CITY OF HUXLEY

HUXLEY CITY COUNCIL CHAMBERS
A SESSION OF THE CITY OF HUXLEY'S
PLANNING AND ZONING COMMISSION

HUXLEY, IOWA
MEADOW LANE PLAT 3
FINAL PLAT

HUXLEY, IOWA
INNOVATIVE TECHNOLOGIES SITE
POLE BARN ADDITION
SITE PLAN

MEADOW LANE PLAT 3 EAST
HUXLEY, IOWA
FINAL PLAT

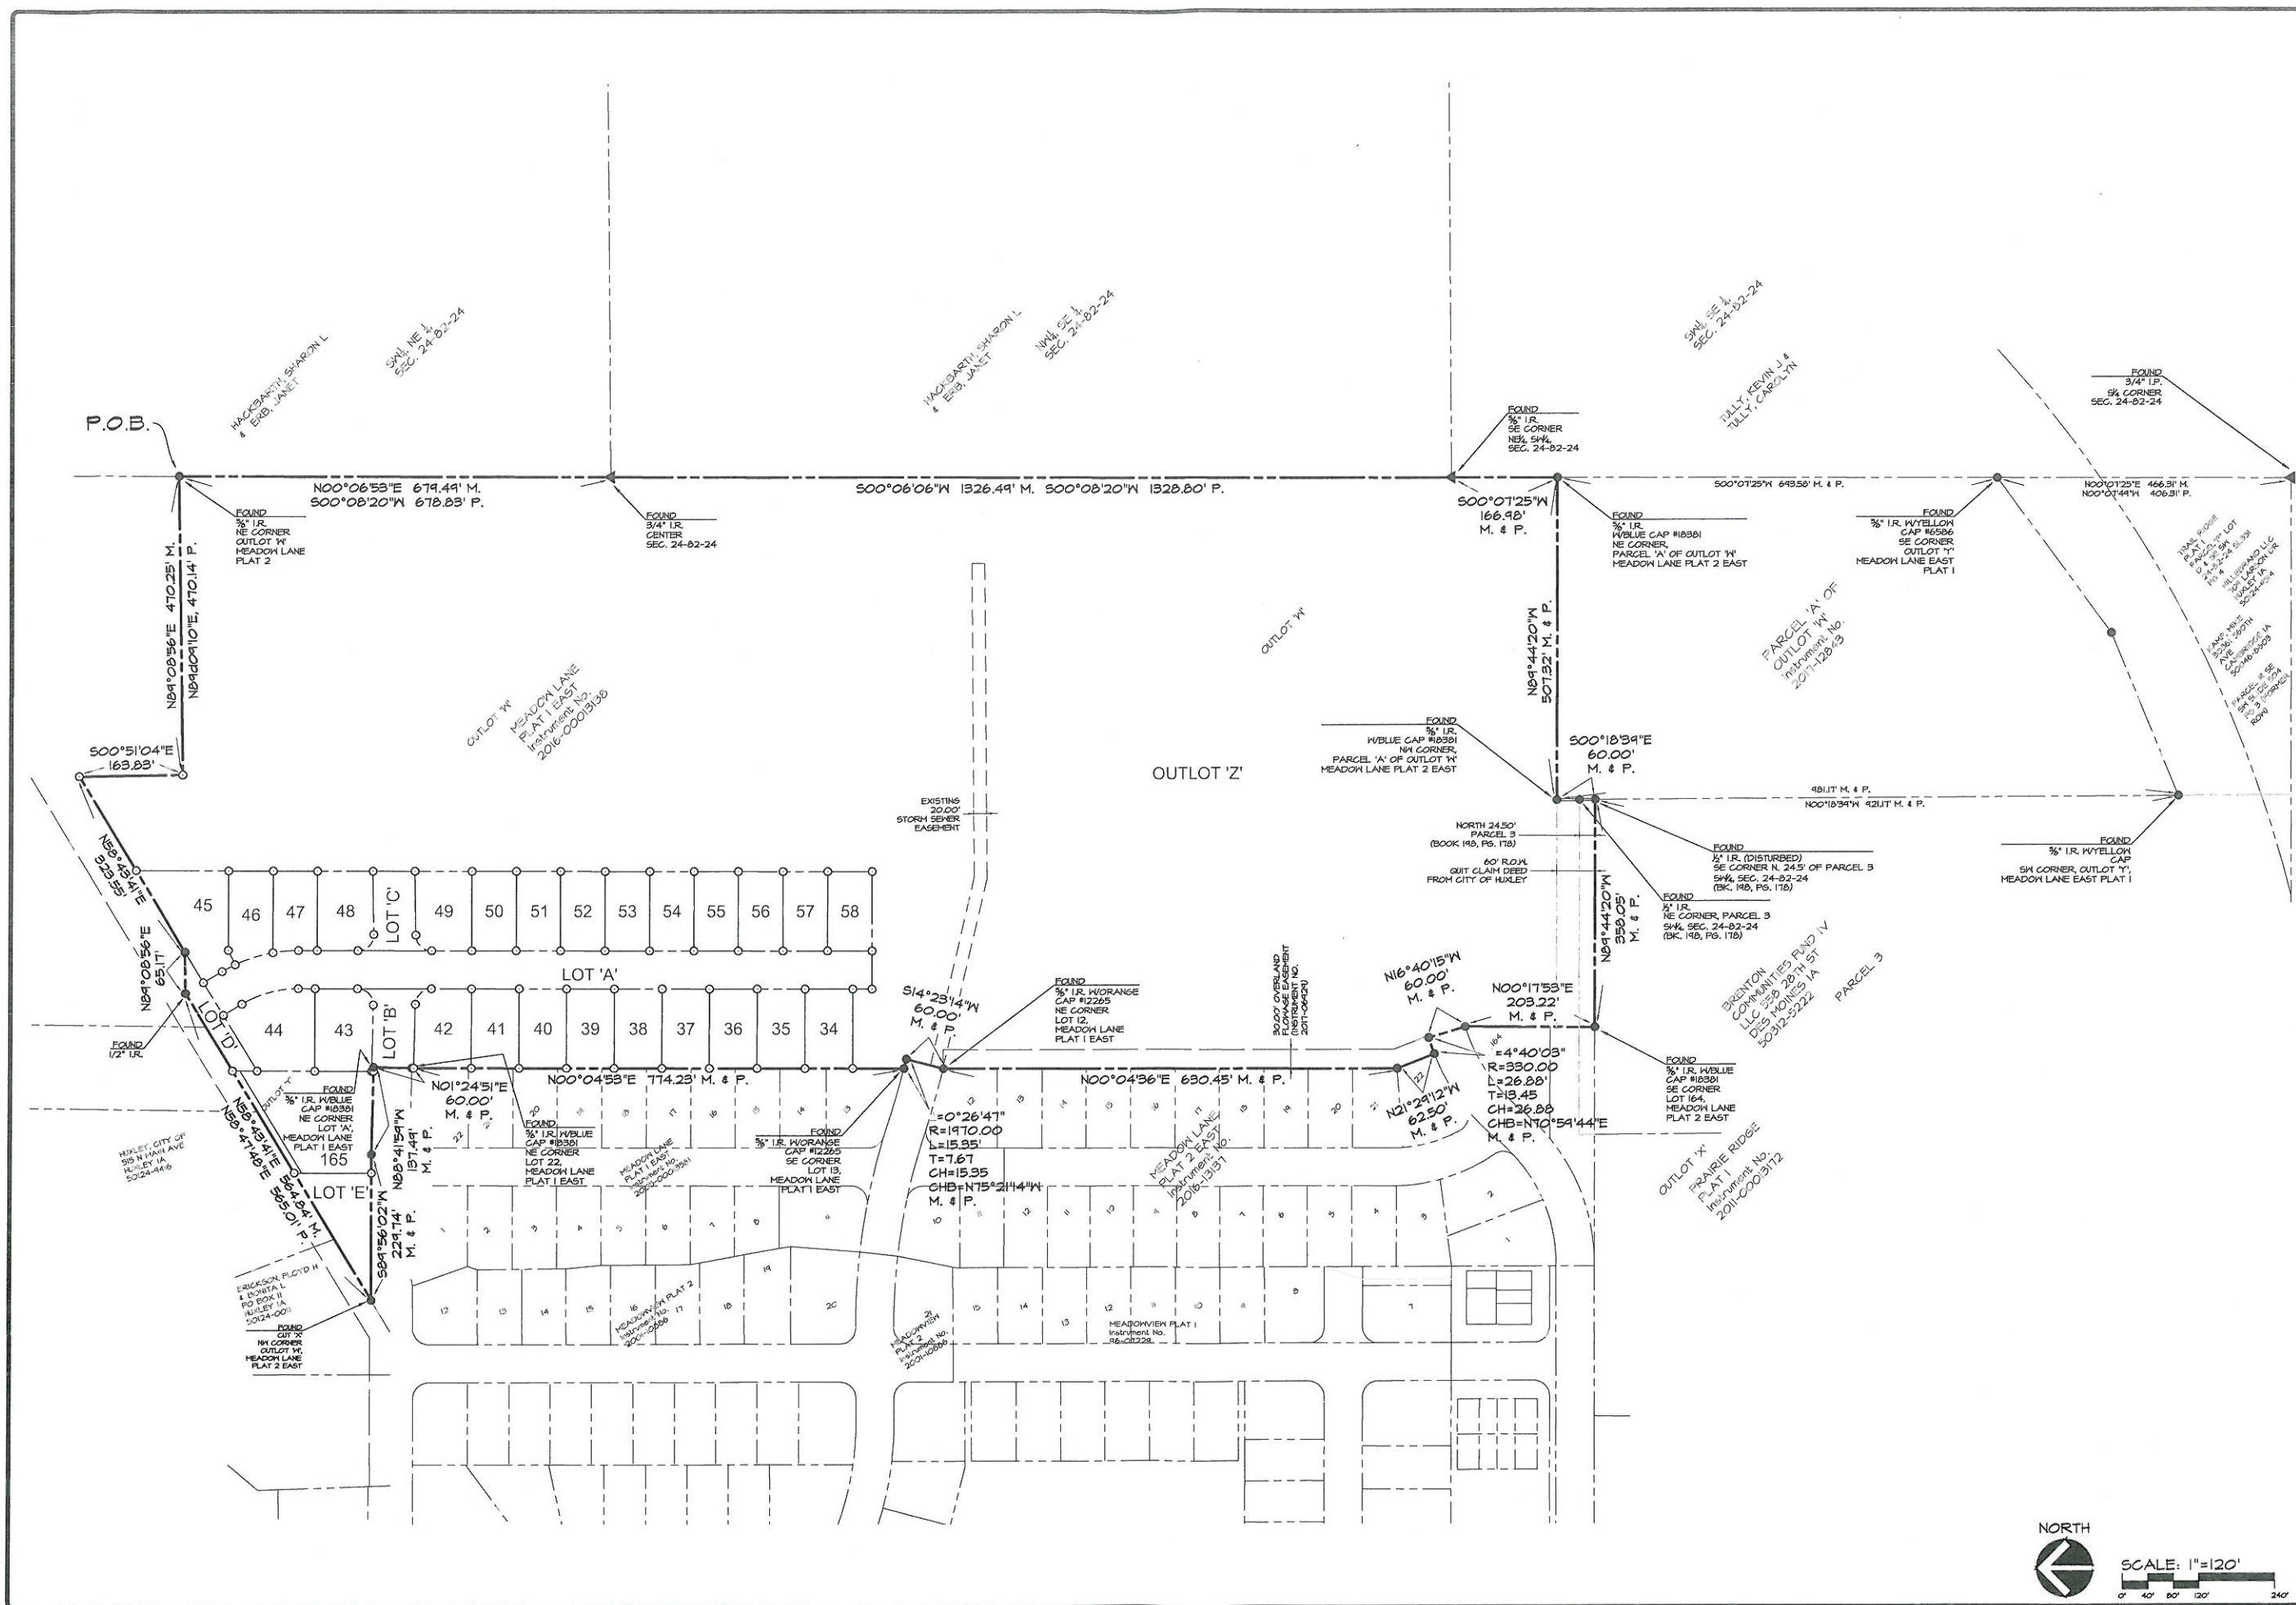
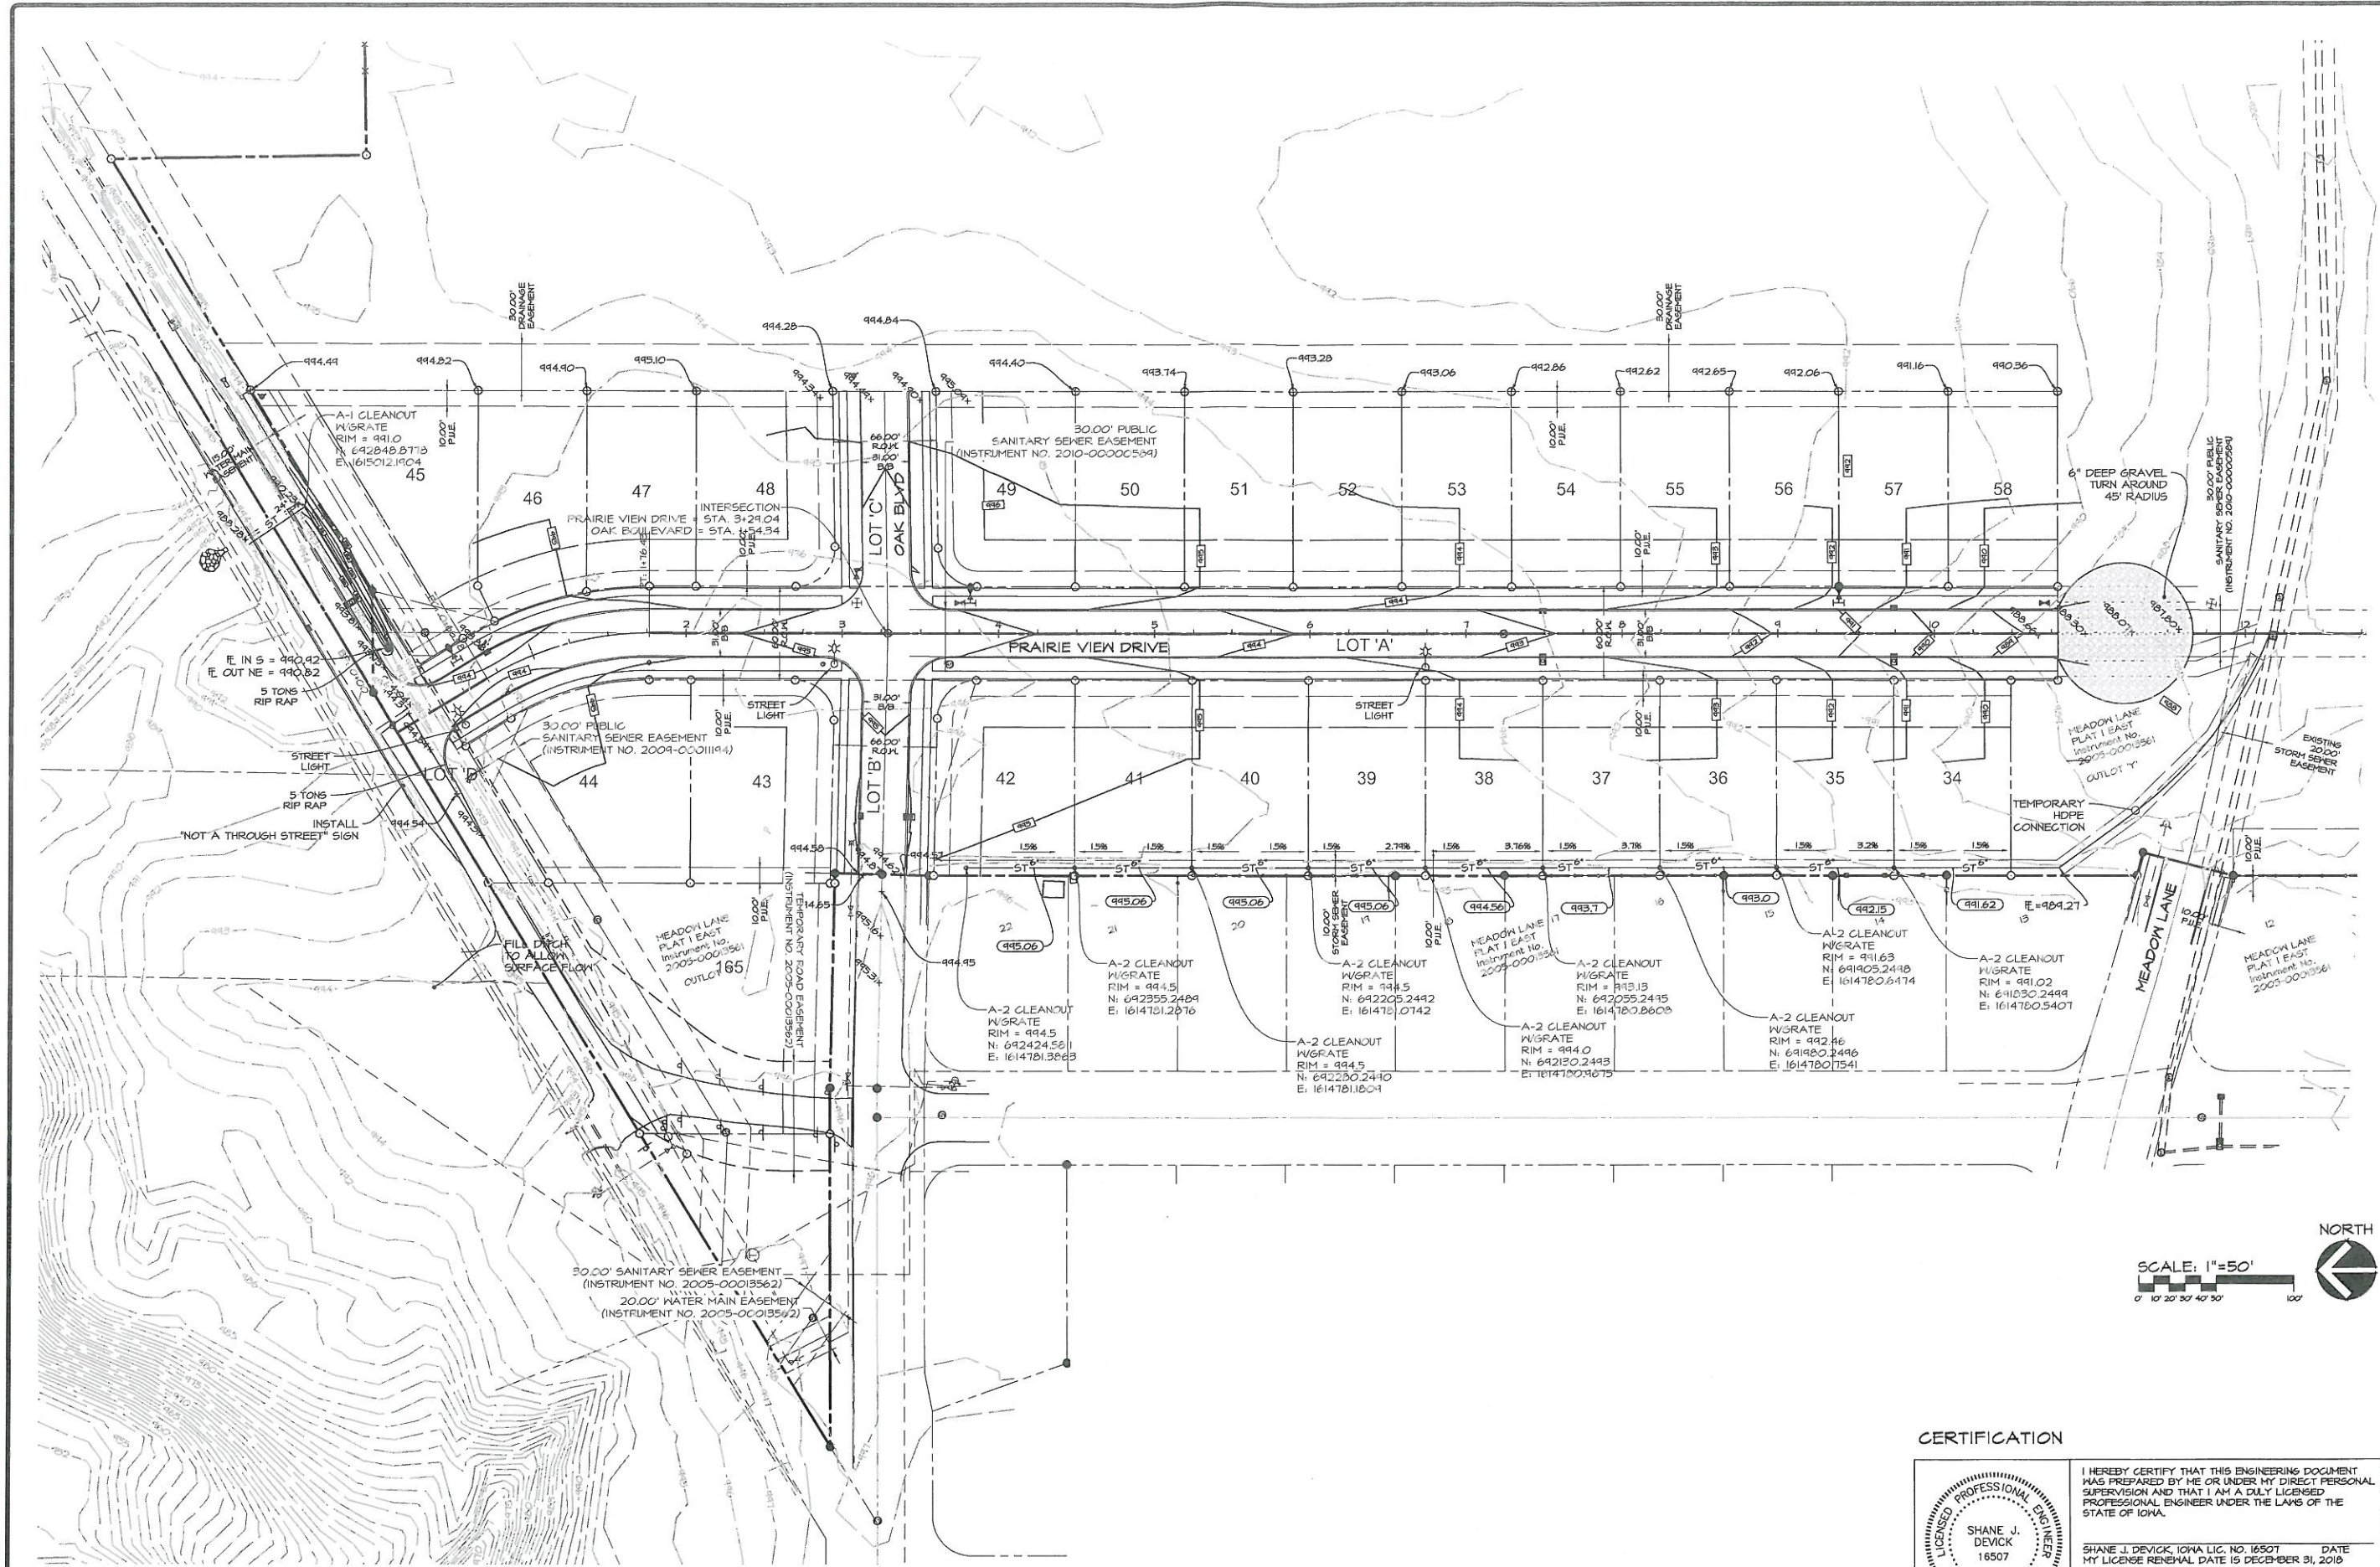
We have reviewed the final plat for Meadow Lane Plat 3 and find it acceptable.

LAYOUT & UTILITY PLAN

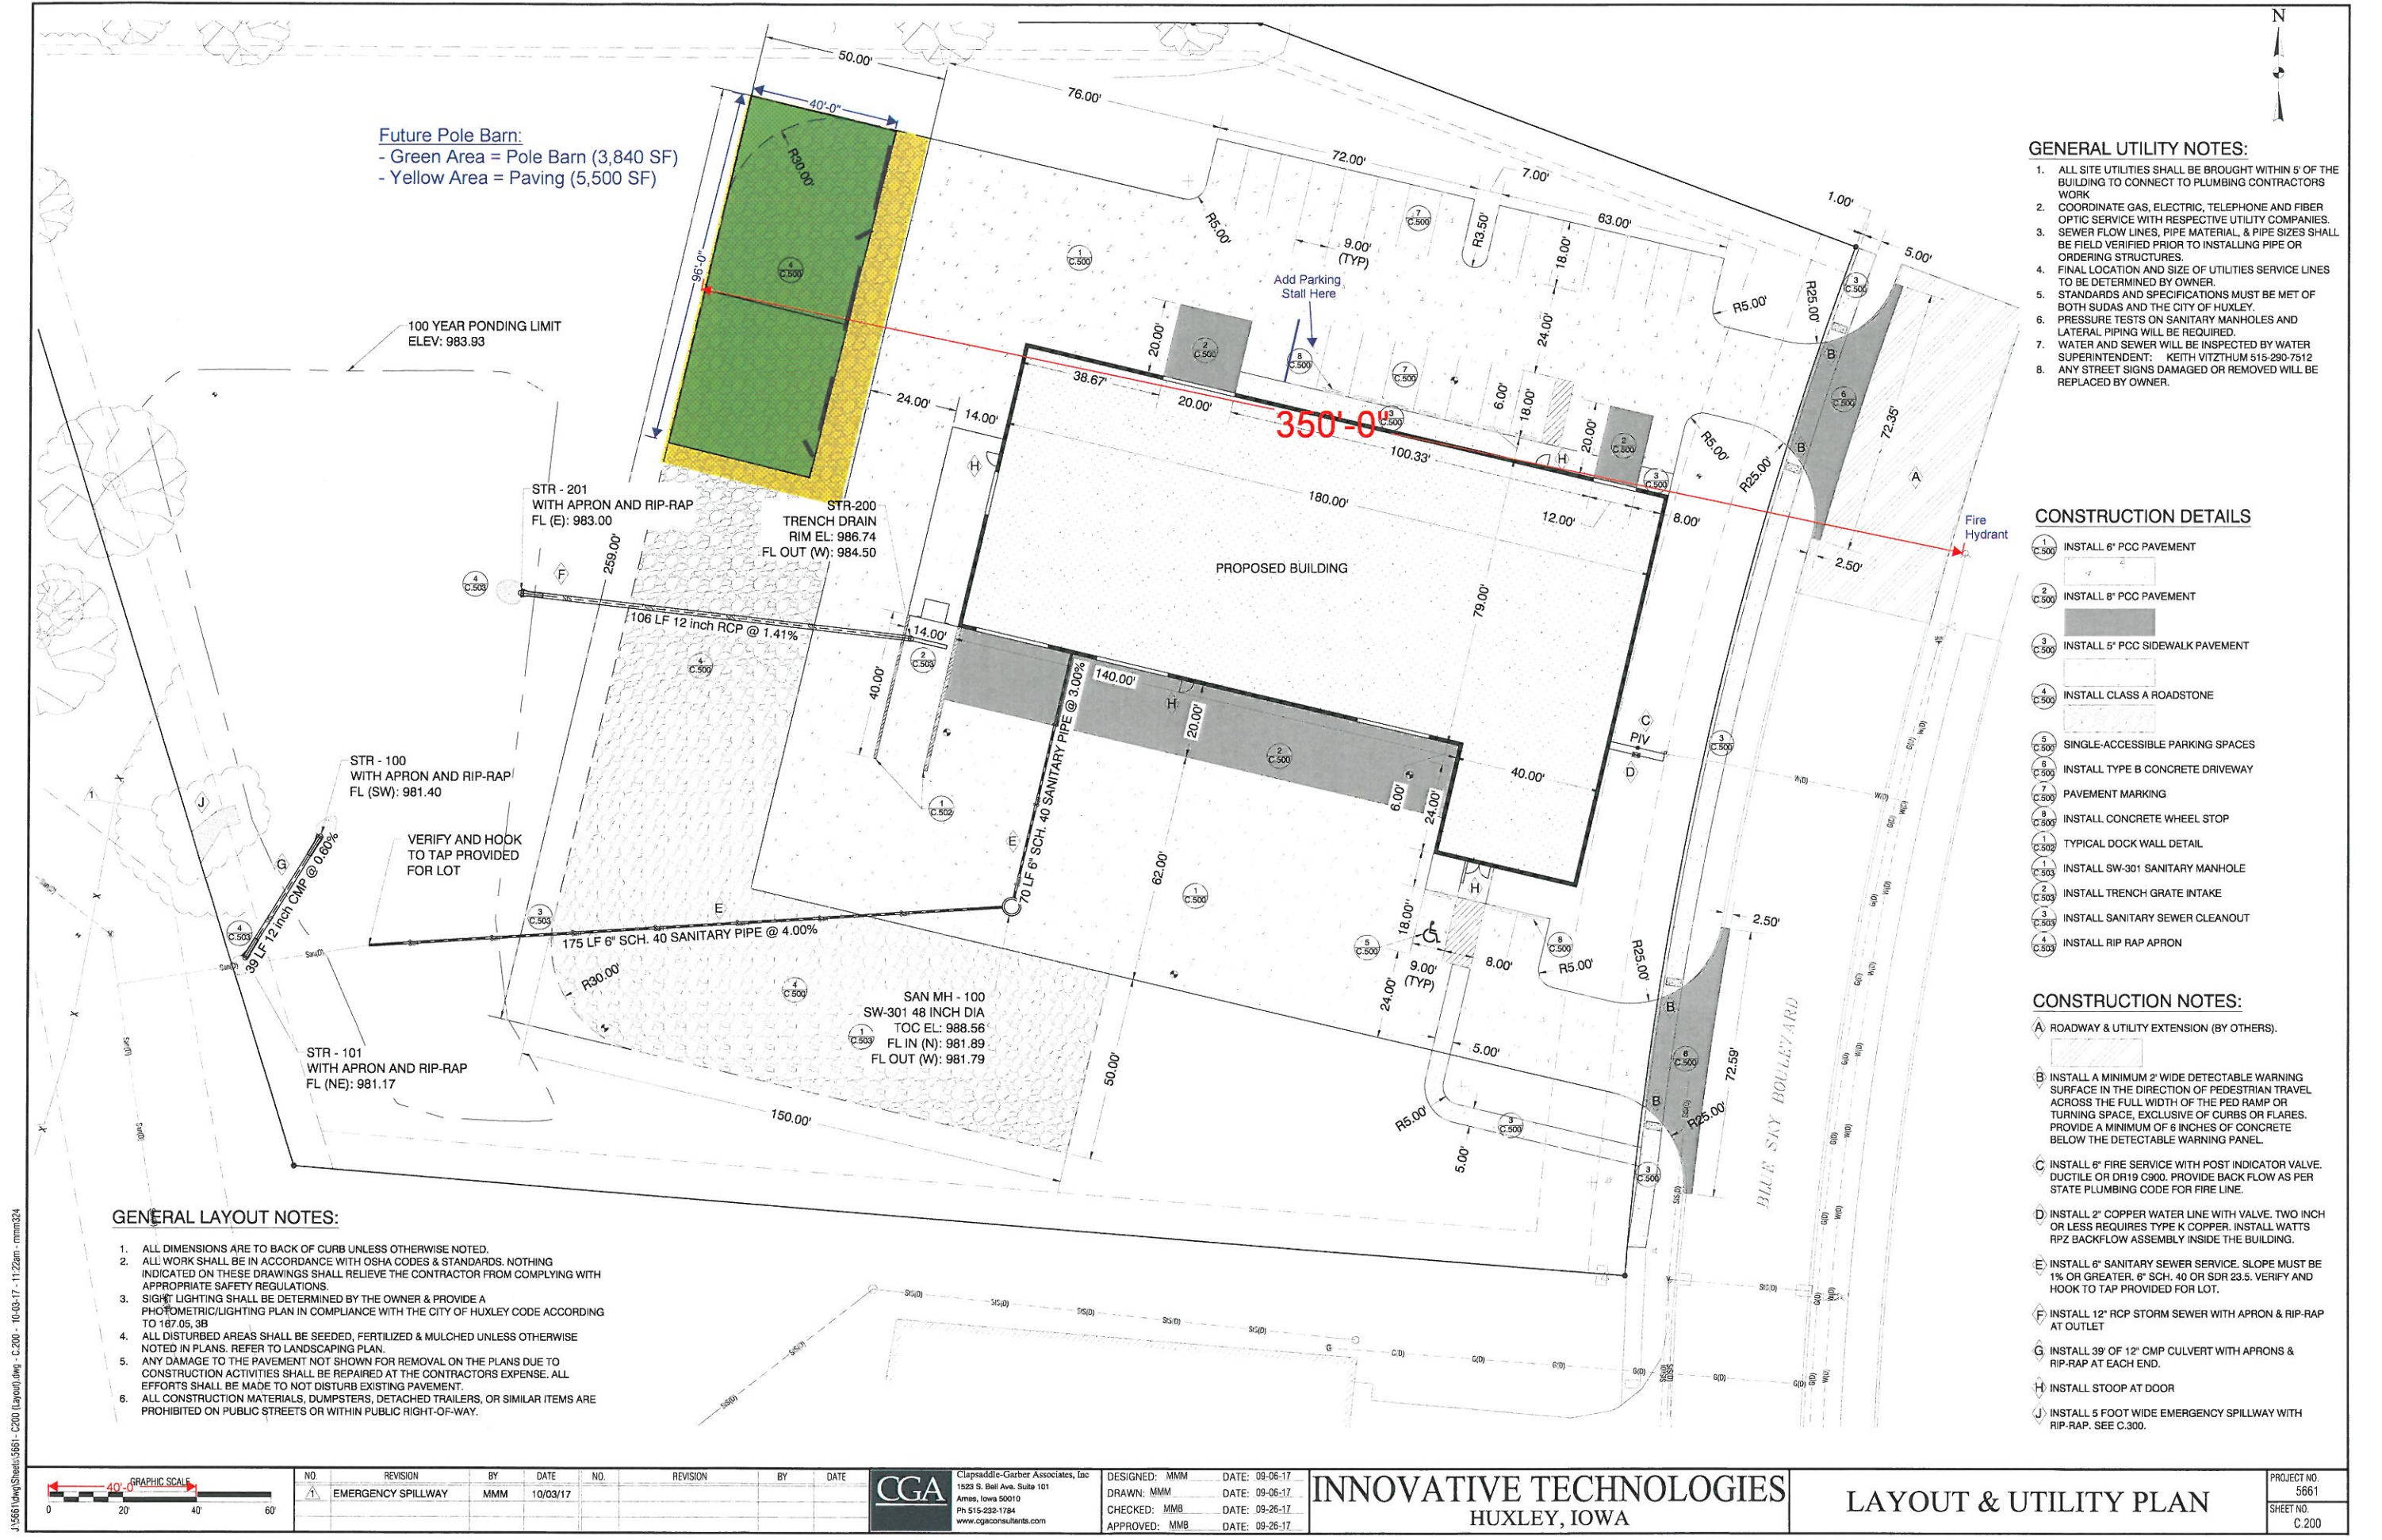
We have reviewed the pole barn addition to the Innovative Technologies Site and find it acceptable with the following items that need to be discussed with the P&Z commission.

1. One parking stall needs to be added. On the site plan this is proposed to be added along the north side of the existing building. This location needs to be confirmed by the developer.
2. The floor of the pole building and the perimeter of the building highlighted in yellow will be paved with concrete pavement. We have no objections to this concept but this plan should be confirmed by P&Z.
